OBJECTION TO DEVELOPMENT PROPOSALS MP_07 0166 MOD 8

MP07_0166 Mod 8 is an application seeking to modify the Wahroonga Estate Concept Plan by providing detailed amended residential building envelopes and amended residential car parking rates for Precinct B: Central Church Precinct. The modification does not seek to alter the total maximum dwellings approved under the existing Concept Plan.

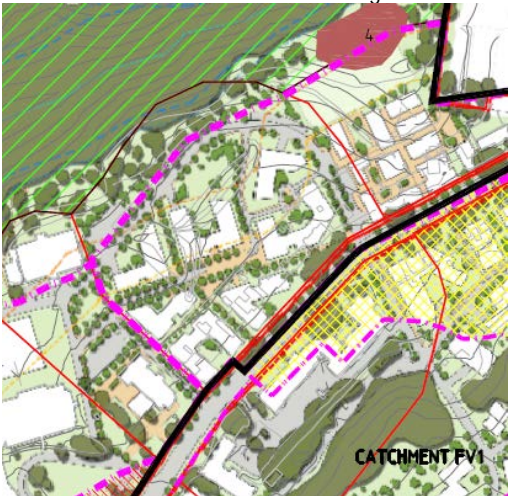
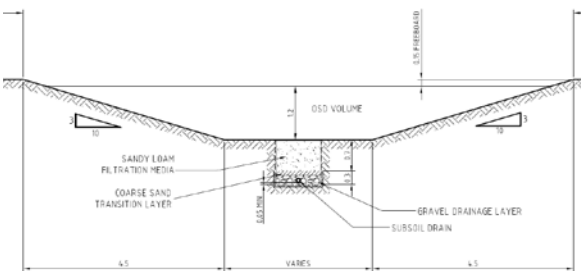
Item	Comments
<p><i>Drawing SKC008 Stormwater Reuse Plan</i> Below is an extract from the above drawing.</p> 	<p>It appears that the stormwater plan (Hyder, 2009) was developed on the basis of an old version of the Wahroonga Estate layout, as the school buildings are shown further west along Fox Valley Road than they are in the Final Approved Concept Plan.</p> <p>Within the document titled <i>Wahroonga Estate Redevelopment Incorporating Sydney Adventist Hospital – Final Preferred Project Report & Concept Plan</i> prepared in January 2010 it states in <i>Section 10 Draft Statement of Commitments</i> “Water sensitive urban design measures will be provided generally in accordance with the recommendations of the Wahroonga Estate Flooding and Stormwater Master Plan (Hyder Consulting, February 2009) and the approved concept plan”. This statement implies that the stormwater management concept was not revised to reflect the latest Wahroonga Estate layout.</p>

<p><i>Drawing SKC009 Detention Basins Typical Section</i> Below is an extract from the above drawing.</p>  <p>TYPICAL OSD BASIN/RAIN GARDEN COMBINED SECTION 150</p>	<p>The section indicates that the OSD volume is 1.2 metres in depth and extends to the top of the filtration media. An important component of a raingarden (also known as bioretention system) is what is referred to as the extended detention depth (EDD) which extends from the surface of the filtration media up. The EDD assists with the removal of pollutants from the stormwater.</p> <p>The EDD should not be included in the determination of the OSD volume. This is noted in Section 3.3.9 of the <i>Bioretention Technical Design Guidelines</i> (Version 1.1, October 2014). The reason for this is the EDD is typically drawn down via the filter media at a slower rate than the dedicated flood storage volume.</p> <p>Therefore, either the reported detention volumes in each basin need to be reduced and therefore the overall site OSD requirements will not be met, or the footprint of each basin must be increased to cater for both the OSD requirements and raingarden requirements.</p>
